Staff
Summary
Report

Agenda Item Number 19
Meeting Date: 03/18/99
Doc. Name: 990318devsrh03
Supporting Documents: Yes

SUBJECT: SONIC DRIVE-IN #SGF-99.23

BRIEF: This the first public hearing for Sonic Drive-In for a Third Amended General Plan of Development at 630 West Elliot.

SITE PLAN

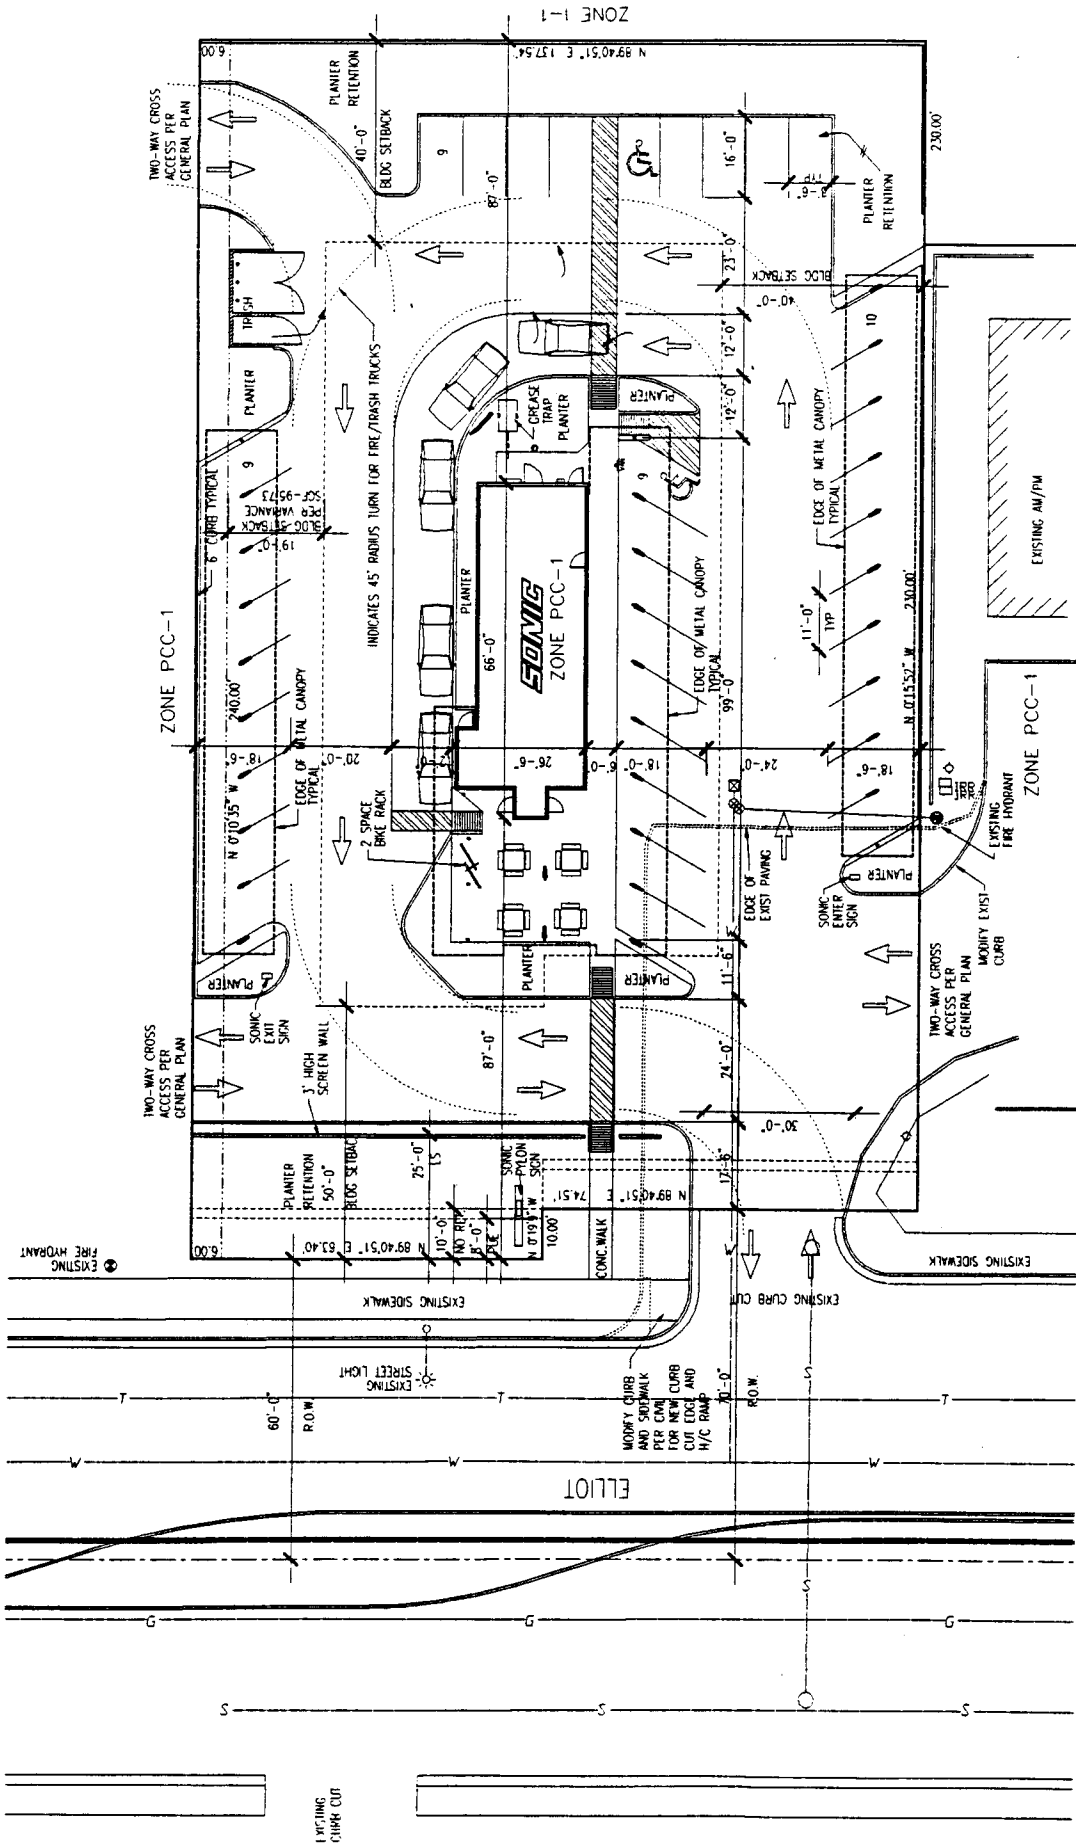
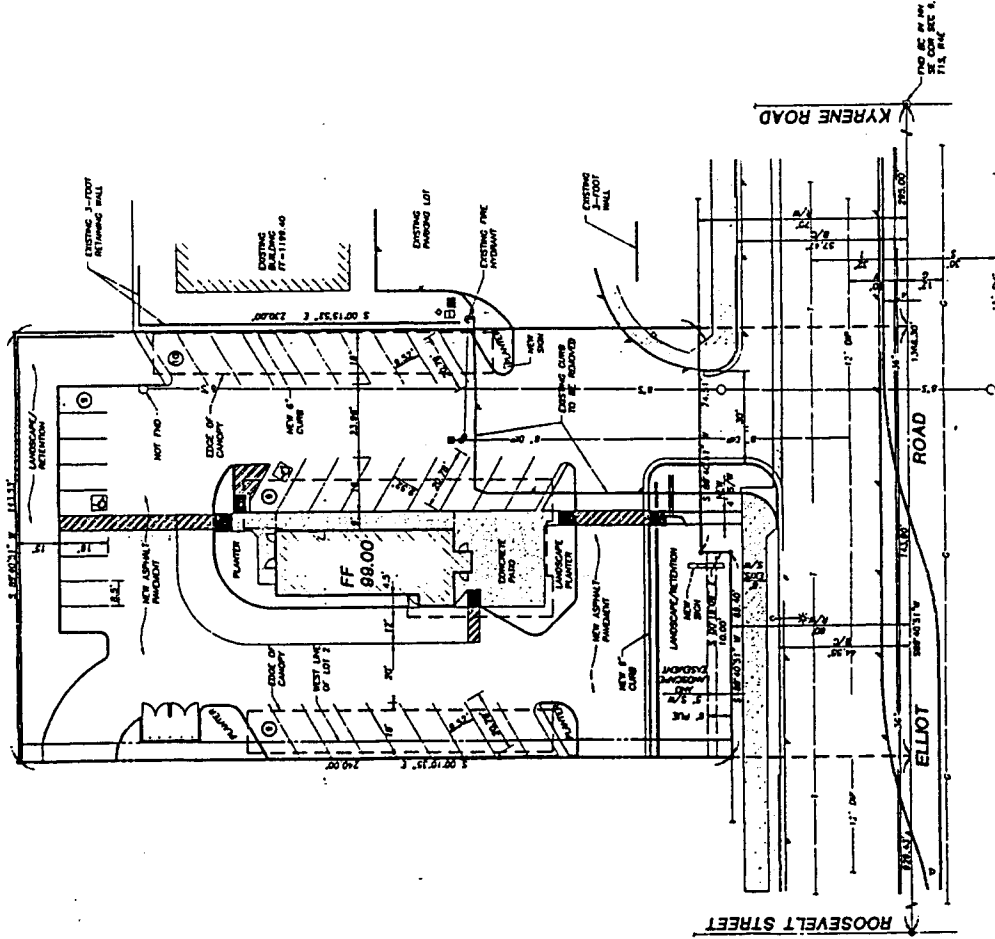
1. Provide a pedestrian link to the north property line in an upgraded paving material.
2. Locate all parking lot area lights so that they are not in landscape islands and do not conflict with tree locations.

3. Provide upgraded paving materials, such as unit pavers, exposed aggregate, or colored concrete, as accents for all pedestrian sidewalks on the site, for a crosswalk across the parking area to the building, at the main entry to the building, and at all the main drives to the site.

10. Locate the electrical service entrance section (S.E.S.) inside the building or provide a screen wall to conceal from view.
11. All canopy lighting shall not extend below the bottom of the canopy fascia. ~~is to be recessed into the canopy soffit and have flat lenses. Details to be approved by Staff. Modified by the Staff~~

2 SIDE ELEVATION
SCALE 1/4"=1'-0"

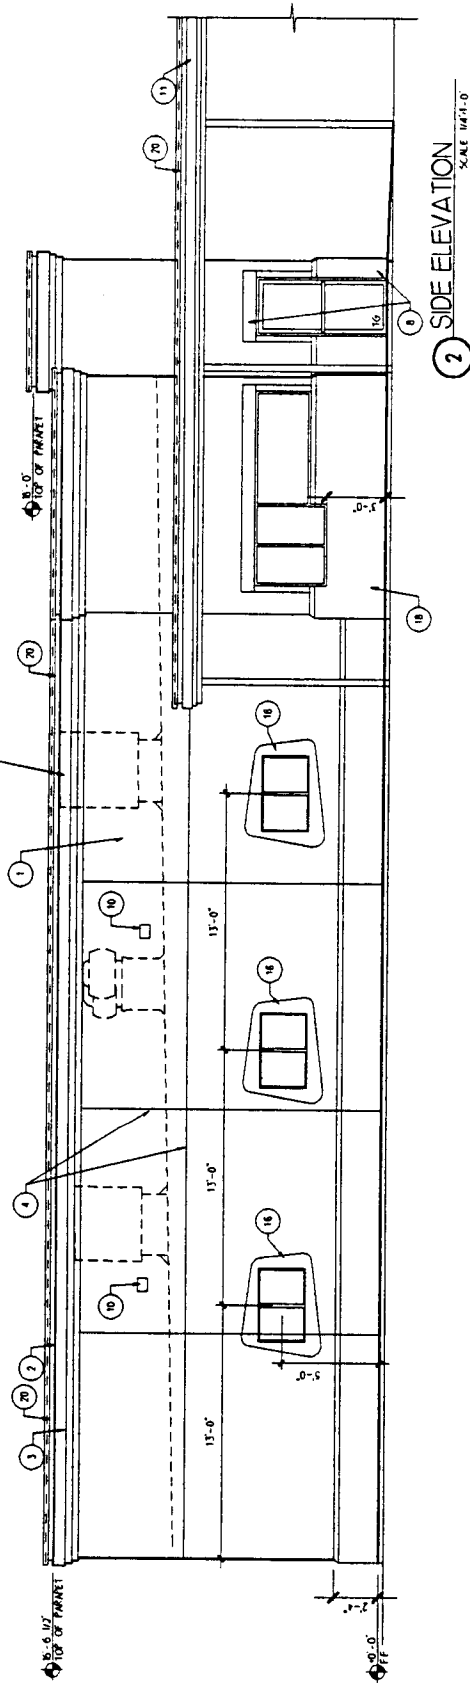
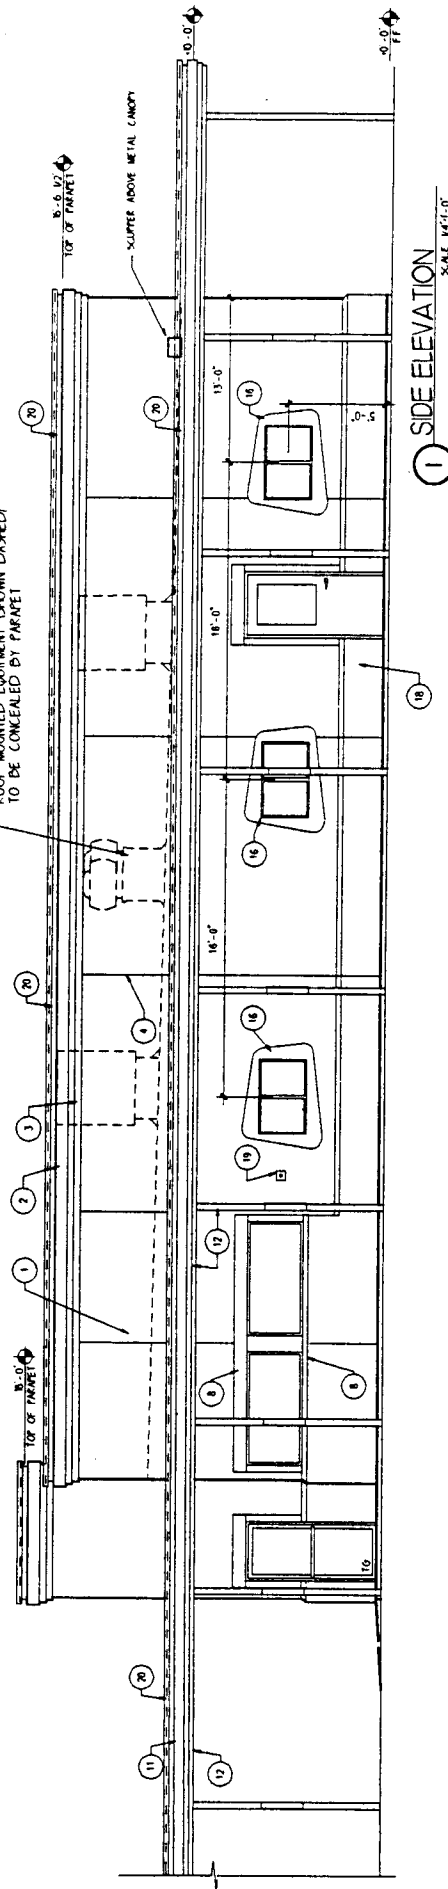
19. Provide details of signage for review.
20. No exposed conduit or raceways are allowed for any new signage.
21. Delete marquee signs from the east and west elevations.
22. Address numbers shall be of contrasting colors, with dedicated illumination and not obstructed by landscape or other conflicts. Address numbers must be shown on front and rear building elevations.
